**SUSQUEHANNA STEAM ELECTRIC STATION
REQUEST FOR ADDITIONAL INFORMATION (RAI) FOR THE
REVIEW OF THE SUSQUEHANNA STEAM ELECTRIC STATION
UNITS 1 AND 2, LICENSE RENEWAL APPLICATION (LRA)
SECTIONS 2.2, 2.3.3, 2.3.4
PLA-6276**

**Docket Nos. 50-387
and 50-388**

Enclosure: PPL Responses to Request for Additional Information (Sections 2.2, 2.3.3, 2.3.4)

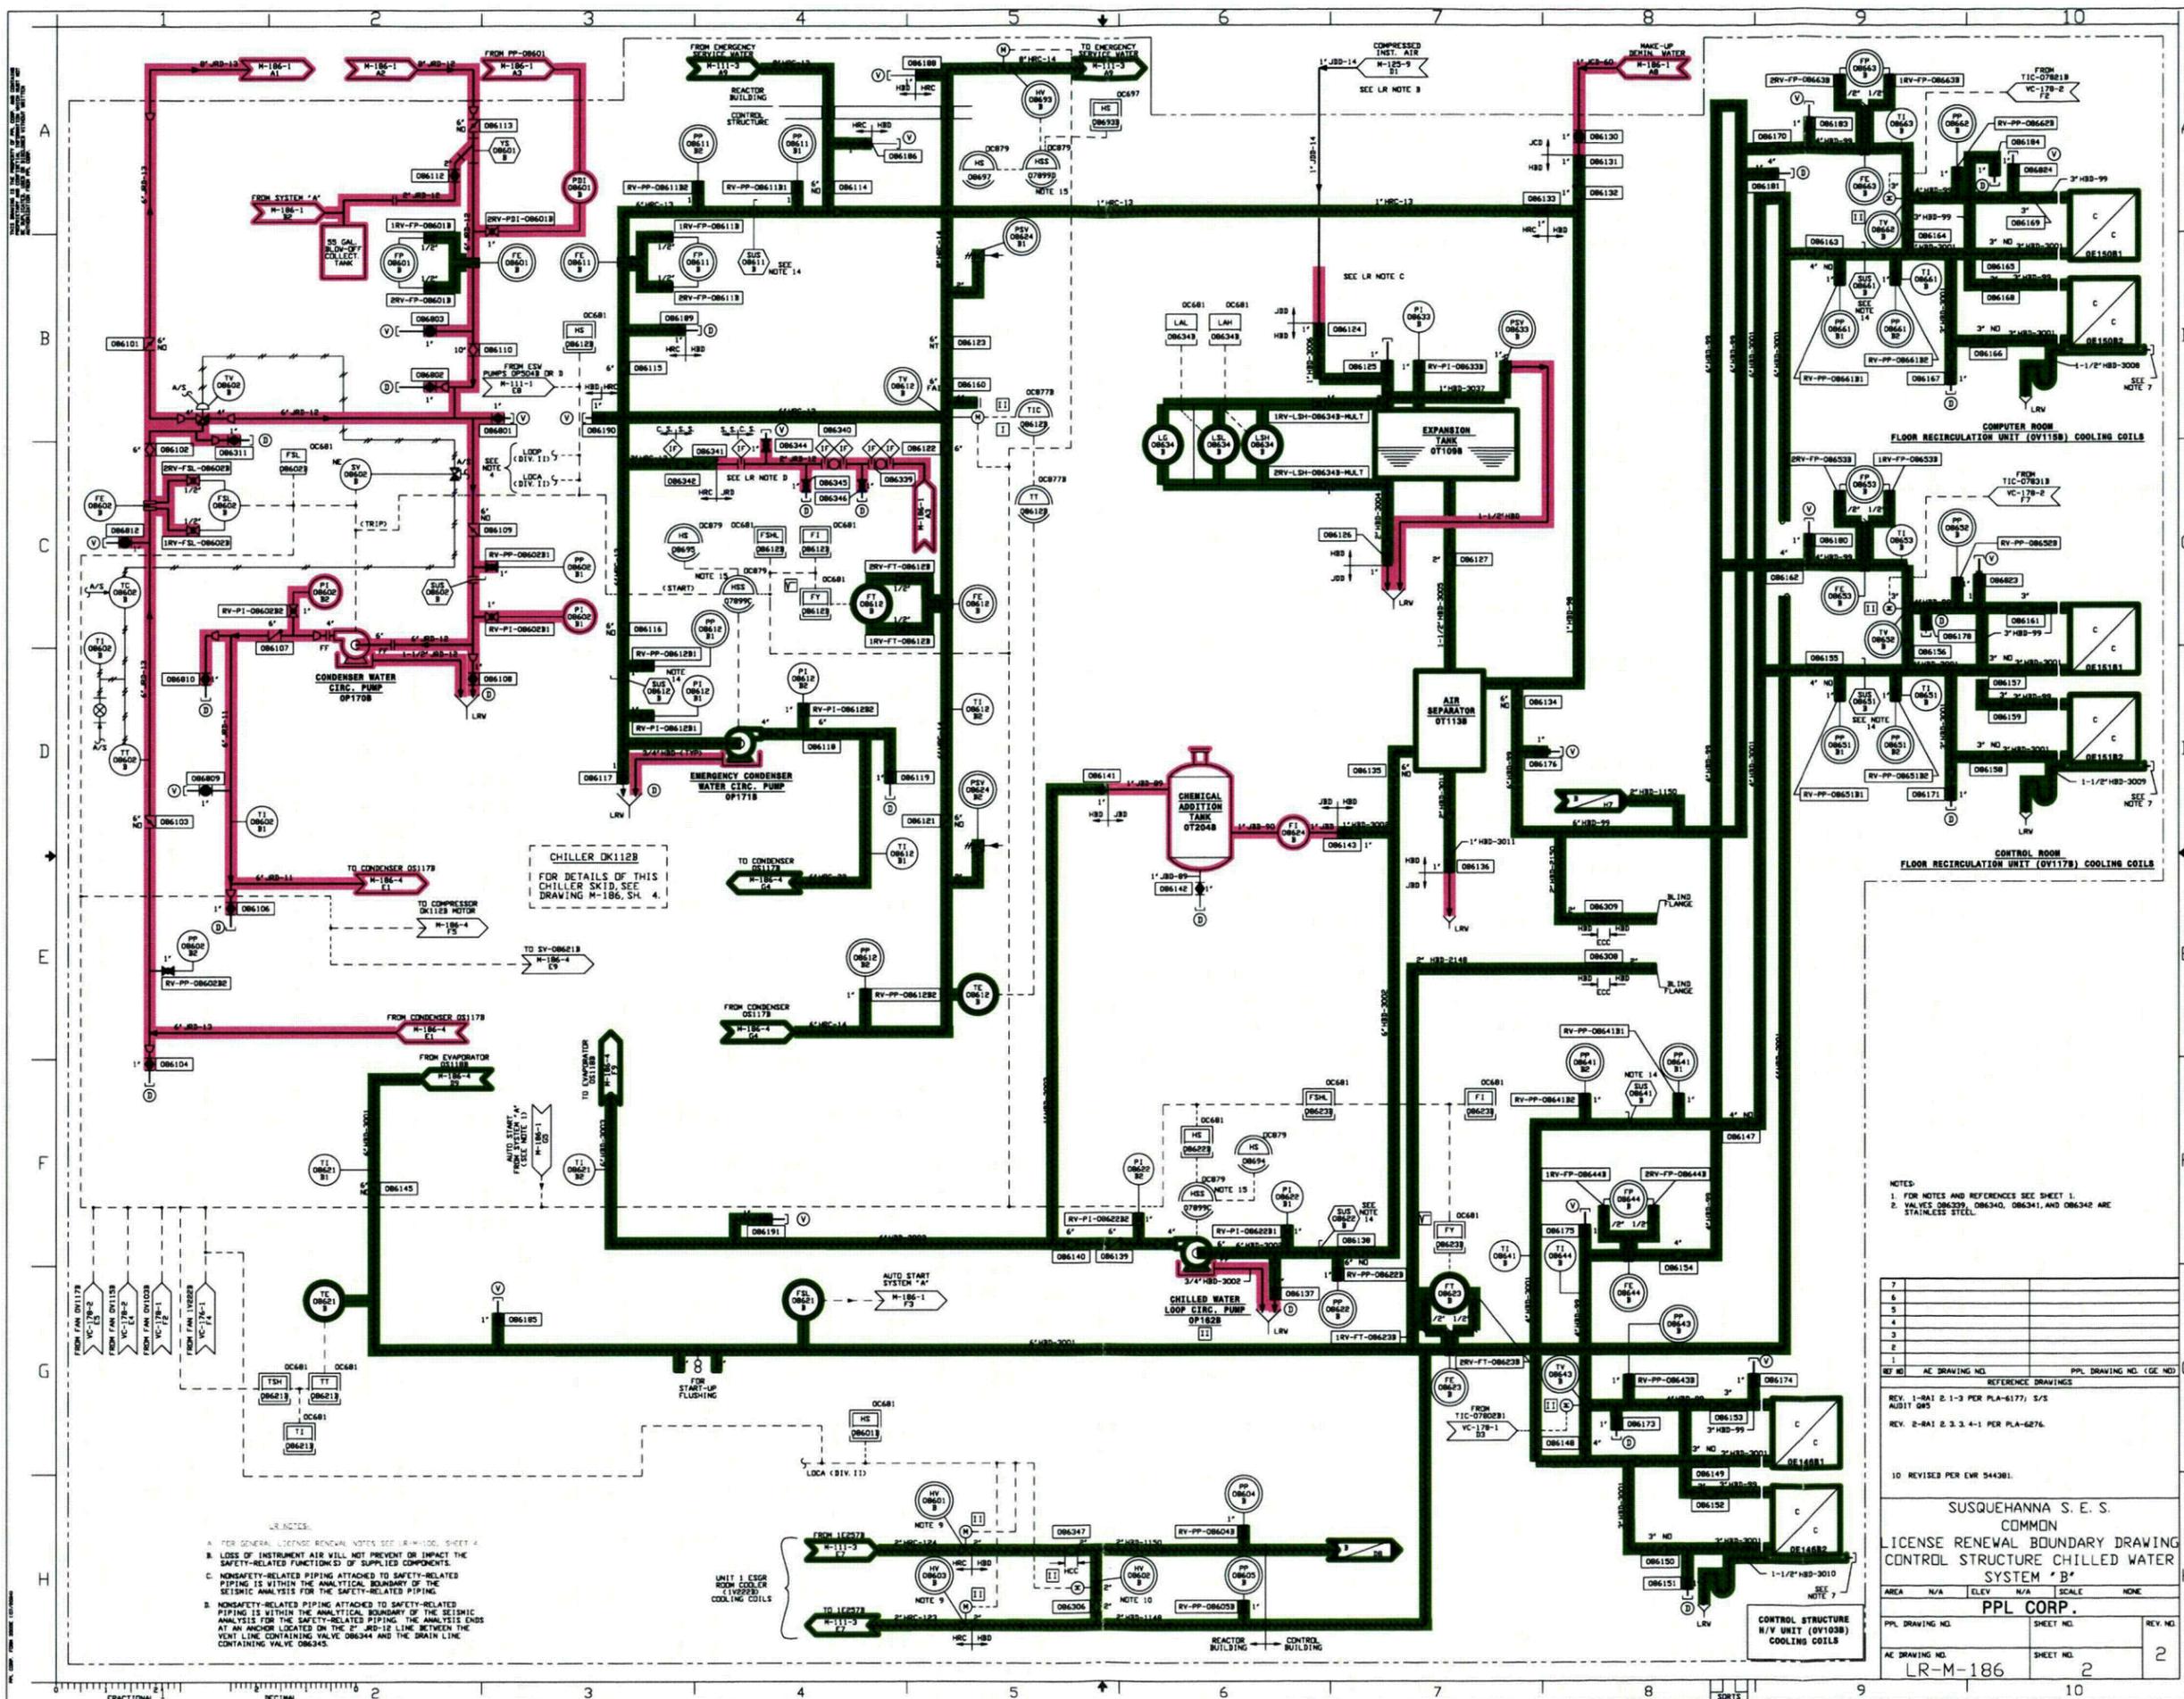
License renewal drawing LR-M-186-1, location A3, shows nonsafety-related piping that has the potential for spatial interaction with safety-related piping, based on criterion 10 CFR 54.4(a)(2) and it is continued on drawing LR-M-186-2, location C5 that is not within the scope of license renewal. Provide additional information on why the continuation on drawing LR-M-186-2 is not within the scope of license renewal and justify the boundary locations with respect to the applicable requirements of 10 CFR 54.4(a).

DRAWING	CONDITION	CHANGE
LR-M-186-1	2" JRD-12 at A3 is not highlighted. The pipe is within the scope of license renewal for (a)(2).	Highlight pink (magenta) 2" JRD-12 at A3 to the continuation arrow to "M-186-2 C5".
LR-M-186-2	2" JRD-12 at C4 is not highlighted. The pipe is within the scope of license renewal for (a)(2).	Complete highlighting pink (magenta) 2" JRD-12 from the continuation arrow at C5.
